ADDENDUM NO. 1 TO 19-0096-4

FOR: COOPERATIVE EXTENSION SERVICE REHABILITATION

ADDENDUM No. 1

PROJECT: Cooperative Extension Services Rehabilitation (Bid No. 19-0096-4)
Chatham County Georgia

8 GRAVITY HOOD DETAIL
M2.01 NTS

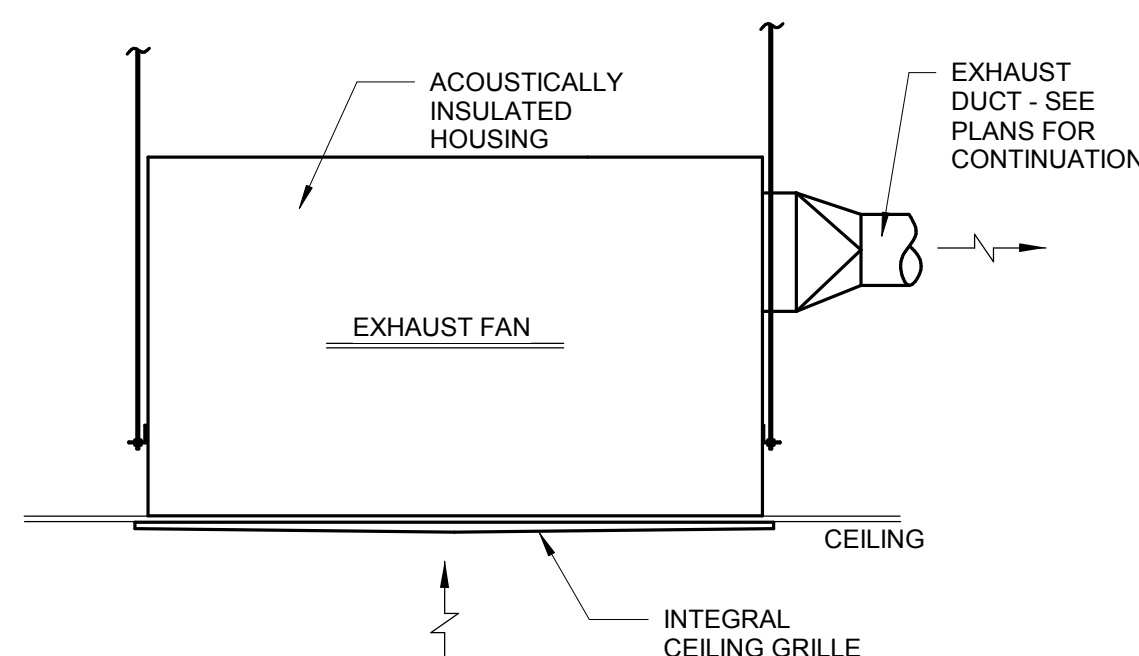
- M. Detail 8 on sheet M2.01 shows bar joists for the support of the new gravity hood with a note to refer to the structural drawings. However, no structural drawings were provided. Is there any information that can be provided for the structural support of the new gravity hood?

1.A/E Response: Refer to revised Sheet 8.41 and M2.01 included with this addendum.
